Modifications Notices

Board to FPC Connectors

No. 2014178AE(ON)

FPC/FFC connector (a part of Model XF2J series) - Modification Notice of Emboss tape width change for the quality improvement.

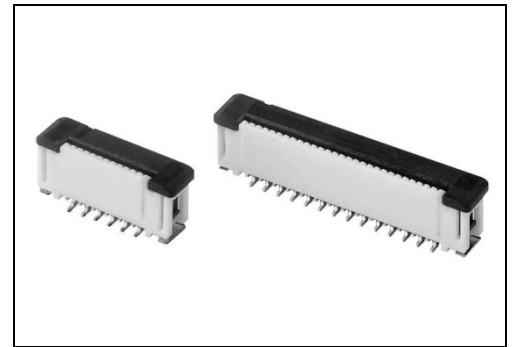
For improving stability of peel strength of top tape.

Before the change	After the change
<p>Width of emboss tape (A)</p> <p>Width of emboss tape: 16.0 mm XF2J-0624-11A(-R100) XF2J-0824-11A(-R100)</p> <p>Width of emboss tape: 24.0 mm XF2J-2024-1□A(-R100) XF2J-2224-1□A(-R100) XF2J-2424-12A(-R100)</p> <p>Width of emboss tape: 32.0 mm XF2J-2824-1□A(-R100) XF2J-3024-1□A(-R100)</p>	<p>Change width of emboss tape (A')</p> <p>Width of emboss tape: 24.0 mm XF2J-0624-11A(-R100) XF2J-0824-11A(-R100)</p> <p>Width of emboss tape: 32.0 mm XF2J-2024-1□A(-R100) XF2J-2224-1□A(-R100) XF2J-2424-12A(-R100)</p> <p>Width of emboss tape: 44.0 mm XF2J-2824-1□A(-R100) XF2J-3024-1□A(-R100)</p>
